Product Change Notification

PCN# 20160901000

- PCN for SR-uSOM-MX6 Rev 1.3
- Transition from SR-uSOM-MX6 Rev 1.3 to SR-uSOM-MX6 Rev 1.5
- SR-uSOM-MX6 Last Time Buy (LTB) notification

Date of publication: September 15th, 2016

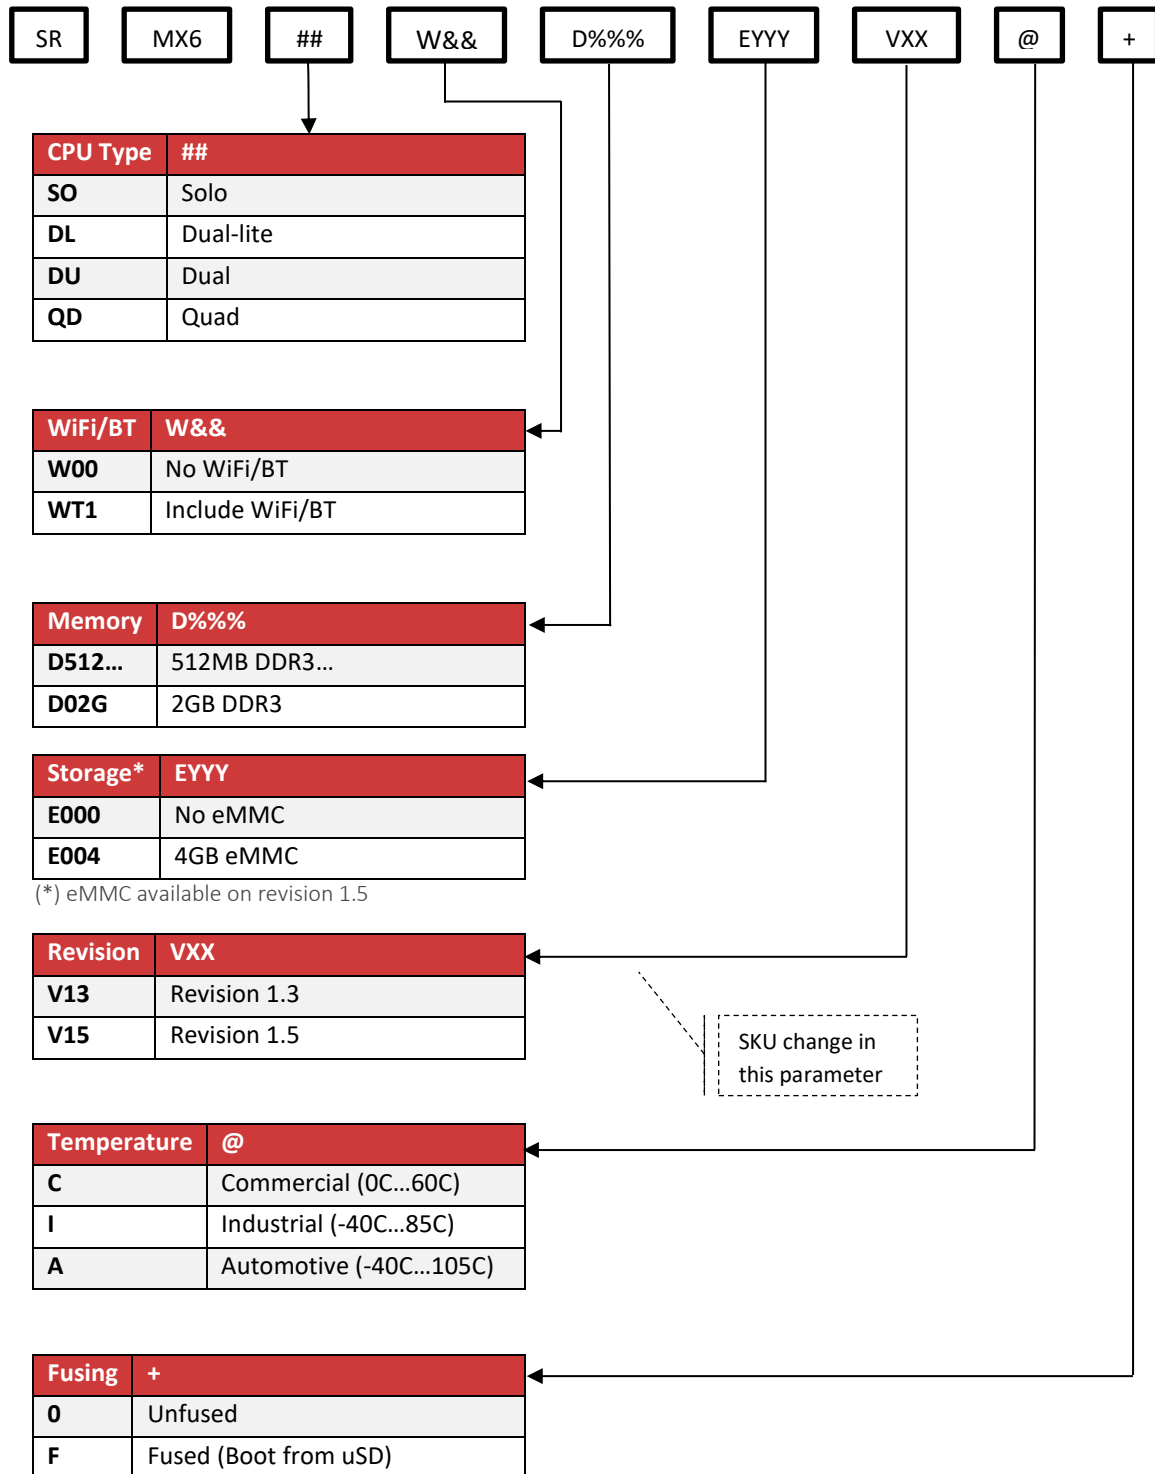
1. Placement of antenna UFL connector has changed. Refer to the below diagram of placement of new antennas.
2. A second UFL antenna connector was introduced to support dual antenna TI WiLink 8 SKUs. Default build of the SR-uSOM-MX6 assumes single antenna.
3. Placement of i.MX6 device and DDR has shifted slightly. Refer to the below diagram.
4. Additional 3rd mechanical hole was added but can be used **ONLY** if eMMC is not assembled on SR-uSOM-MX6 Rev 1.5.
